AGENDA
VILLAGE OF SUSSEX
PLAN COMMISSION MEETING
6:30 PM TUESDAY, MAY 21, 2024
SUSSEX CIVIC CENTER – BOARD ROOM 2nd FLOOR
N64W23760 MAIN STREET

RE: Plan Commission meeting of May 21, 2024

B. Discussion and possible action on site plan, landscape plan, architecture plan, and lighting plan for Highlands Business Park Site XII.

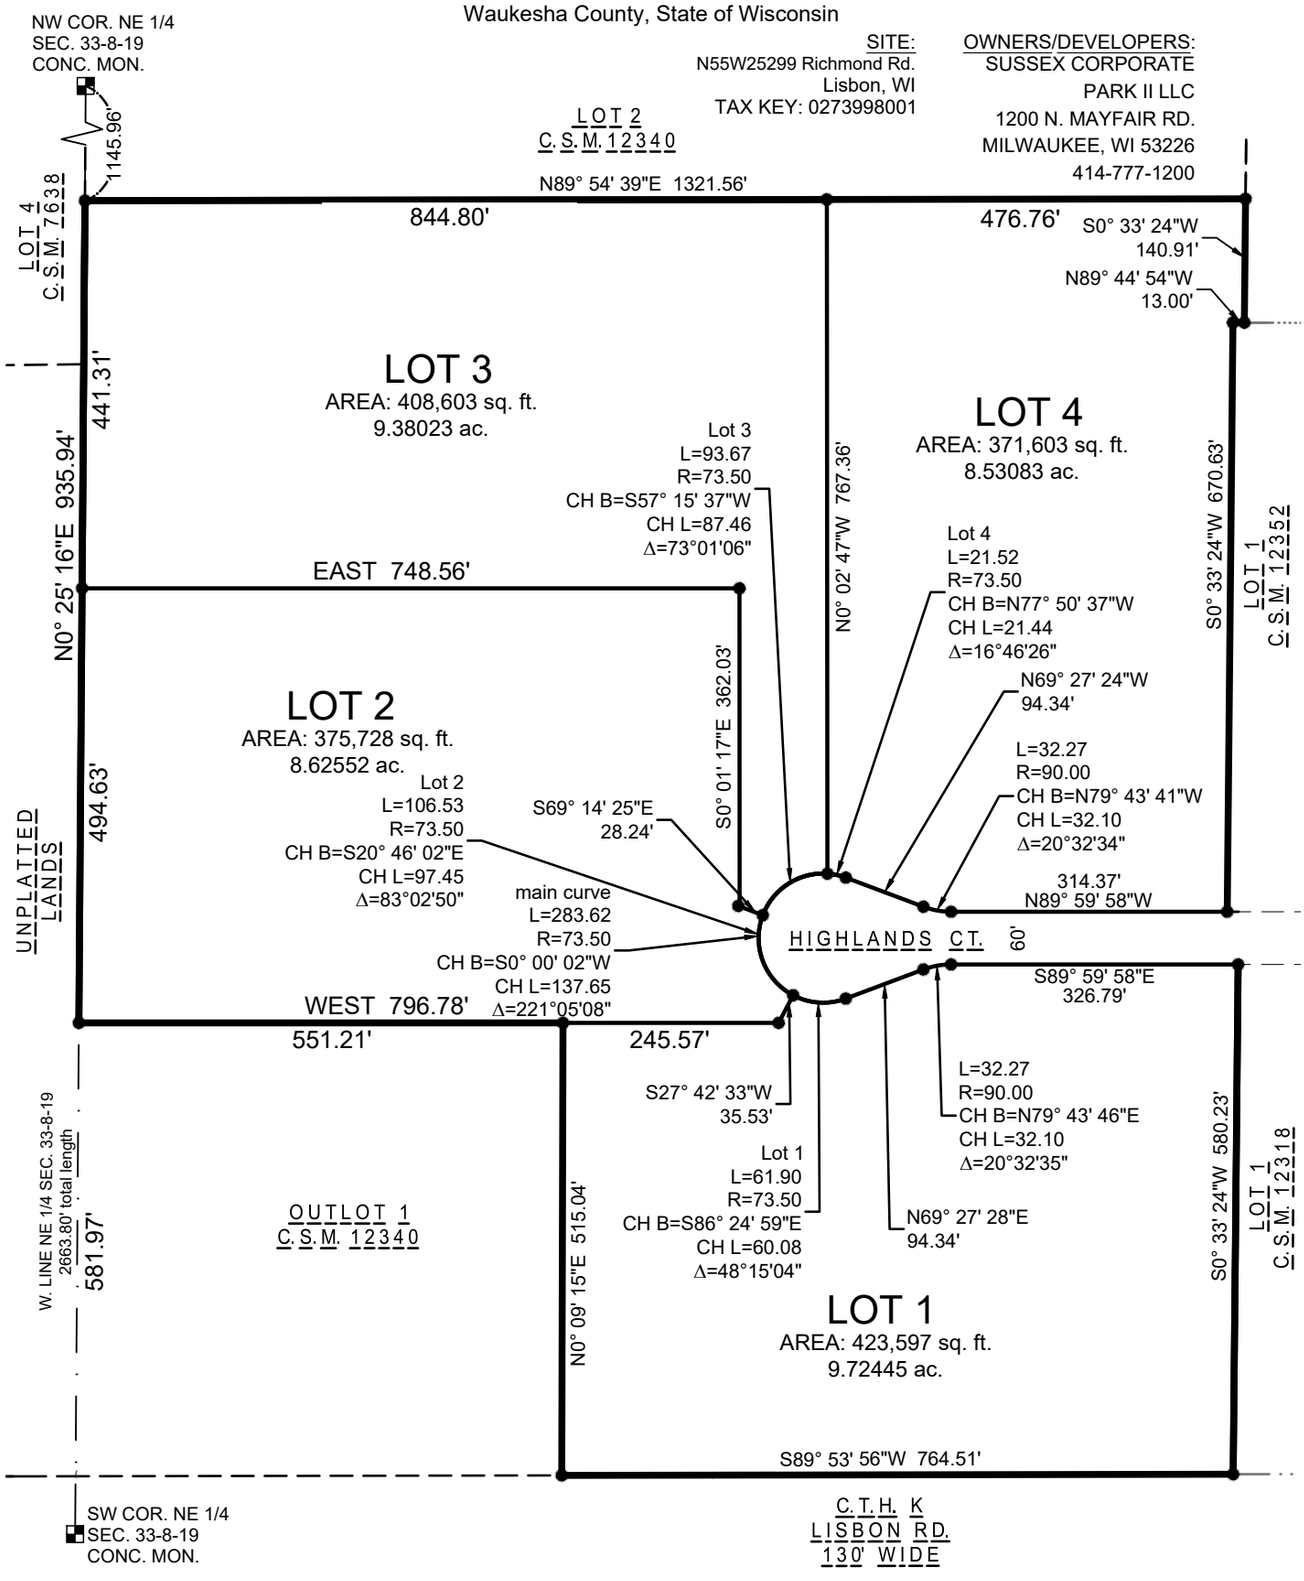
10. Label your easement pages 1 of 2 and 2 of 2. Also label the easements as existing (and the source of the easement) or proposed.
11. On sheet 3 of 7, it looks like this CSM is trying to create an easement on Lot 1 of CSM 12342, which cannot be done. Also, that lot is no longer owned by the Developer, so a separate document that is needed to create this portion of the easement will need to be created (Sussex has a standard template) and it will need to be signed by the new owners of the property.

12. On sheet 5 of 7, Jennifer Moore is Village Clerk (not interim).
13. On Sheet 5 of 7, Once we have a clear understanding of the easements being created by this CSM, we can edit the easement language on this page. I believe that only public Storm Easement are being crated by this CSM. Please verify.

1. Compliance with all comments and conditions listed in the Engineering memo dated May 10, 2024.
2. Submitting a revised Certified Survey Map that includes an access easement over the portion of Lot 3 that is providing access to Lot 2.
